**Affected Models:** 690-WU, 690-WUA, 690-WUB, 690-WUC, 683-WU, 683-WUA, 683-WUB

**Date:** 1-27-2020

**Subject:** Heat Shield 751P19088

**Purpose:** Prevent freezing of the Breather on Affected Model MTD Snow Engines. Order and install one shield per unit as needed.

Figure 1

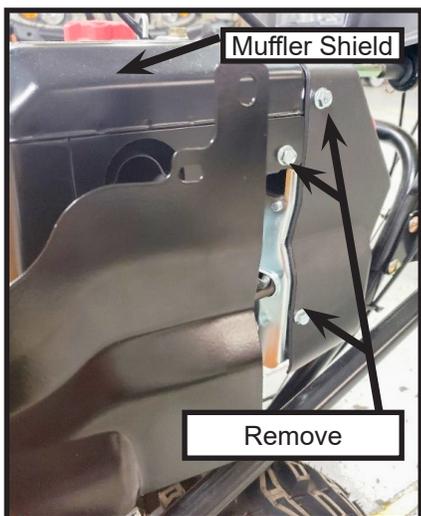
1. Park on a firm flat surface.
2. Allow engine to cool to room temperature.
3. Remove and Retain three M6 Muffler Shield Screws. See Figure 1.
4. Maneuver and Align the slots of Heat Shield **751P10988** into the Left Hand side of the Muffler Shield as shown in Figure 2.
5. Match up the mounting orifice and reinstall two M6 Muffler Shield Screws. See Figure 3.
